Modification instructions for the DuoTherm® 900/9000 series furnaces where the thermostat is in the ground side of the circuit for the purpose of adding a Fan control board.

Wiring schematic for installing a Dinosaur Fan Control board or Fan 50 Plus board in a DuoTherm® 900/9000 furnace

Typical wiring schematic for DuoTherm® 900/9000

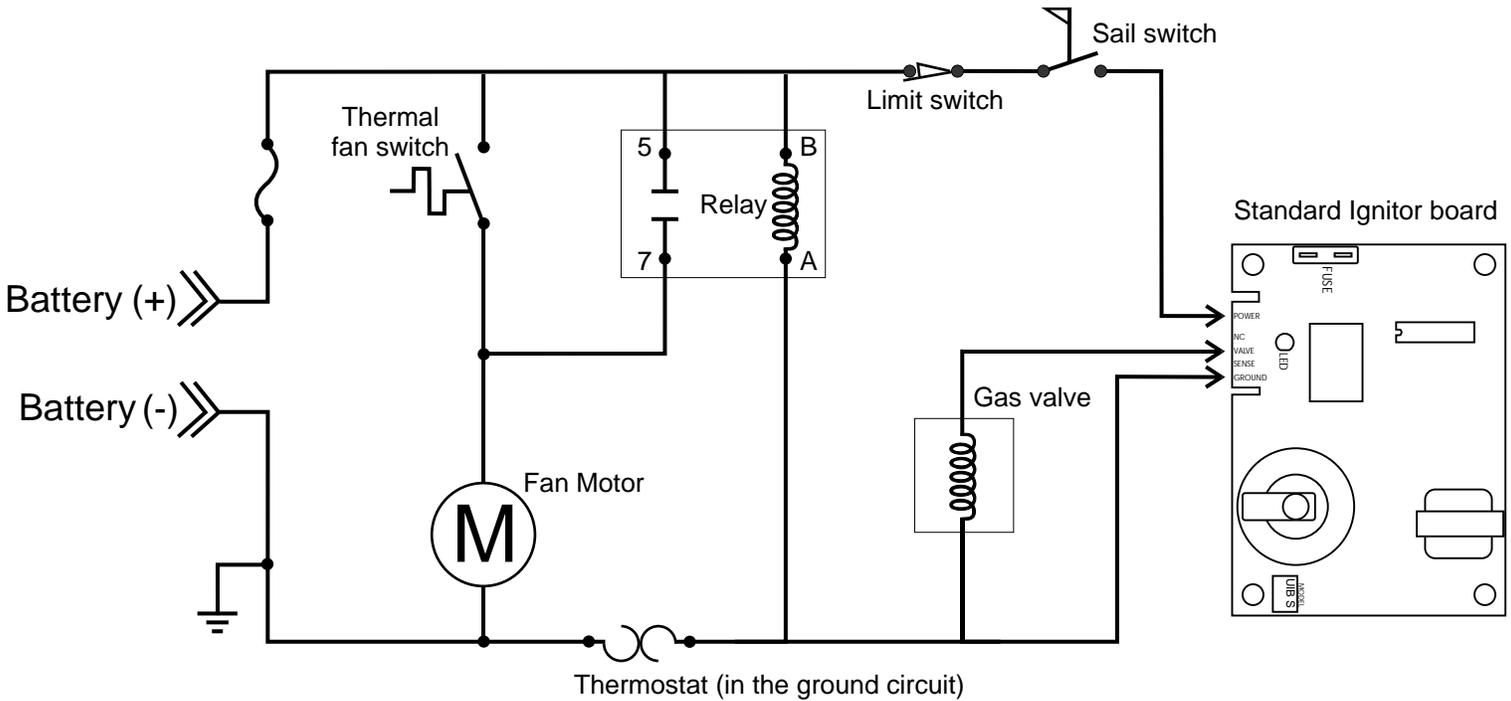
This schematic shows how to wire the thermostat from the ground side of the circuit to the positive side of the circuit so that a "Fan control board" can be installed. These drawings are provided as a courtesy and are to be used at your own discretion. Modification of any gas appliance can void manufacture warranties and/or cause serious injury or fatalities. We recommend that these modifications be done by a qualified service technician familiar with RV gas appliances.

Modified wiring schematic for DuoTherm® 900/9000
